ATR on Quality Control Check Report. (Bungalows)

Bungalow No	15	QC report stage	Column - 2	Sl. No.	29160
Company	KJM	Project	Bloomdale	Phase	—
Prepared by		Sign		Date	
Project Manager		Sign	For Signature	Date	12/02/18
Receipt by QC date		Sign		Other	
Receipt at HO date		Sign		Other	
Checked By MD on		MD Sign		For filling	<input type="checkbox"/> Yes <input type="checkbox"/> No

Quality Control Check Report Stage: After Column Casting (villas)

DESCRIPTION
 Quality Check Plan Ground Floor Slab
 (Type-B West Facing)

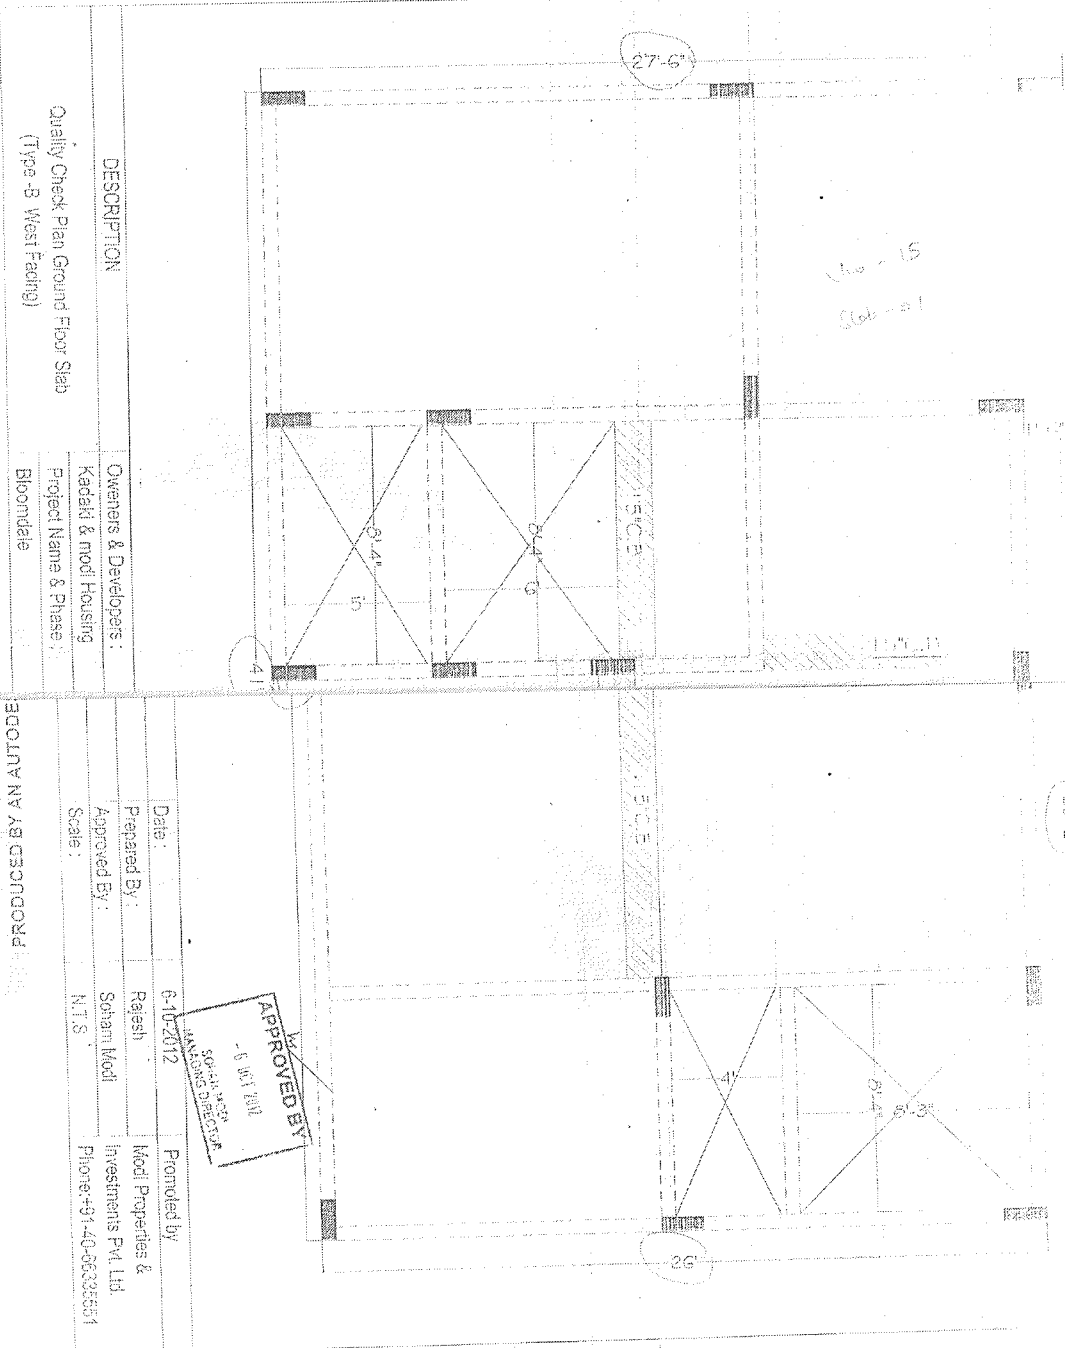
Quality of centering, rod bending and concreting.	<input type="checkbox"/> Good <input type="checkbox"/> Avg. <input checked="" type="checkbox"/> Bad
Quality of centering, rod bending and concreting?	<input type="checkbox"/> Good <input type="checkbox"/> Avg. <input checked="" type="checkbox"/> Bad
Quality of starters?	<input checked="" type="checkbox"/> High <input type="checkbox"/> Medium. <input type="checkbox"/> Low
Number and size of honey combs?	<input type="checkbox"/> Good <input type="checkbox"/> Avg. <input checked="" type="checkbox"/> Bad
Are the honey combs is slab and columns packed?	
Number of beams that are sagging, bulging, caved or deflected in the slab by more than 1"	<input checked="" type="checkbox"/> Yes <input type="checkbox"/> No
Have 6 cubes each for columns and slab casted and numbered for testing?	
Remarks: Note: (1) Very poor concreting work done, honey combs packing also not done for columns.

① The mistake has been corrected to column, C ₂ 8 C ₄ .
② The honey comb's packing also completed.
